# UNITED STATES PATENT AND TRADEMARK OFFICE

APPLICATION NO.	FILING DATE	FIRST NAMED INVENTOR	ATTORNEY DOCKET NO.	CONFIRMATION NO.
10/658,338	09/10/2003	Michael W. Bosse	23122.01	1867

**Office Action Summary**

## **DETAILED ACTION**

Figure 1 of D272,712 to Allen. Lead lines and reference numbers added by the examiner.

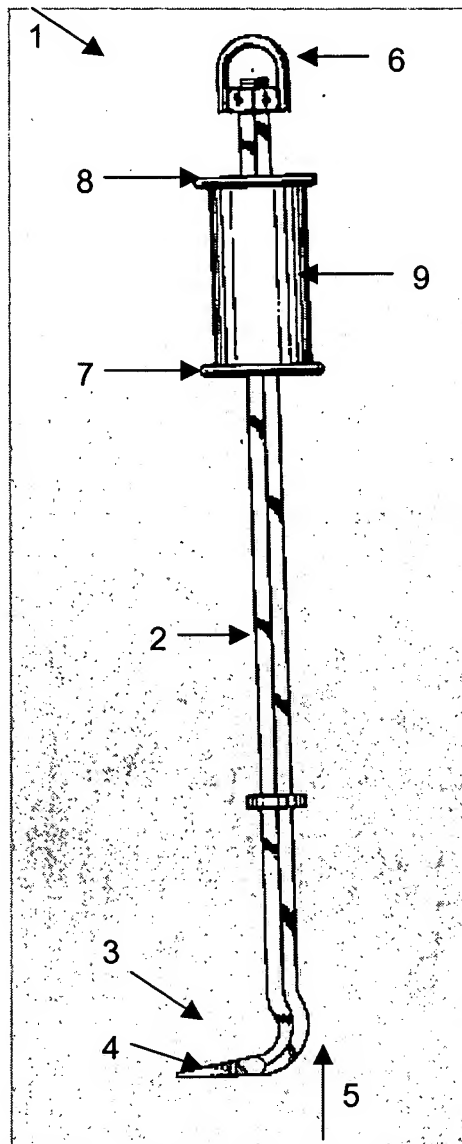
6. Claims 1 and 6-8 are rejected under 35 U.S.C. 102(b) as being anticipated by Allen (D272,712). See the *Figures* section at the end of this Office action.

Regarding claim 1, Allen teaches a lock removal tool (1), comprising: an elongated bar (2) having a first end and a second end; a lock cutting tool (3) disposed on the first end of said bar (2), the lock cutting tool (3) being a generally rectangular, flat plate having leading (4) and trailing edges (5) and top and bottom surfaces, said bar (2) being joined to the lock cutting tool (3) generally between the leading (4) and trailing (5) edges, said bar (2) being angled away the top surface and extending rearward from the lock cutting tool (3); a tool piece (6) extending from the second end of said bar (2)

axially aligned with said bar (2); a first impact collar (7) disposed on said bar (2) near the first end; a second impact collar (8) disposed on said bar near the second end; and a weight (9) slidably disposed on said bar (2) between the first (7) and second (8) impact collars. Note: impact collars (7, 8) are defined as such because they are circular members that impact the tool piece (6) and the lower collar.

Regarding claim 6, Allen teaches the leading edge (4) of said lock cutting tool (3) is bifurcated to form a cutting slot (10), the cutting slot (10) being a generally "V" shaped slot having inner edges.

Regarding claim 7, the top surface of the lock cutting tool (3) is tapered along the leading edge (4).

Regarding claim 8, Allen teaches the leading edge (4) of said lock cutting tool (3) is bifurcated to form a cutting slot (10) being a generally "V" shaped slot having inner edges, the top surface of said cutting tool being tapered along the inner edges (11) of said cutting slot (10).

Figures 4 and 5 of D272,712 to Allen. Lead lines and reference numbers added by the examiner.

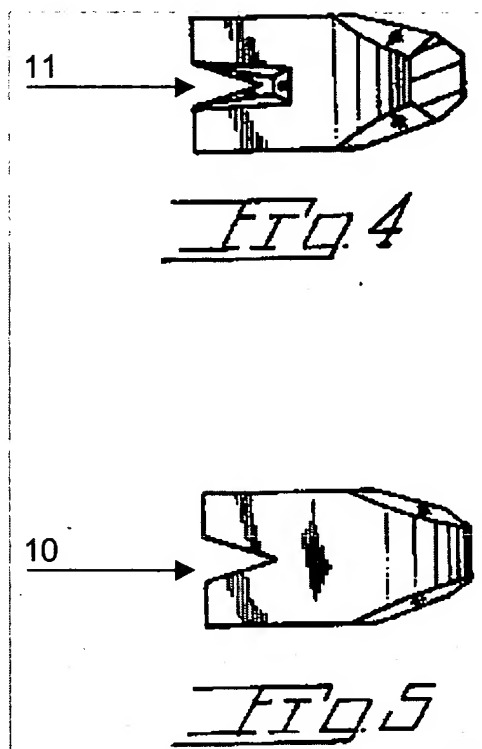
9. Claim 2 is rejected under 35 U.S.C. 102(b) as anticipated by or, in the alternative, under 35 U.S.C. 103(a) as obvious over Allen (D272,712). The cross sections in FIGS 2A and 4 appear to be metal. Therefore, there is a high probability the entire tool, including the tool piece, is formed from metal. However, to the degree it can be argued this is speculative, Official notice is taken it is old and well known in the art to form threaded nuts, such as the tool piece (6), of metal. Therefore, to form parts of metal would have been obvious in order to make the entire tool from metal and long lasting.
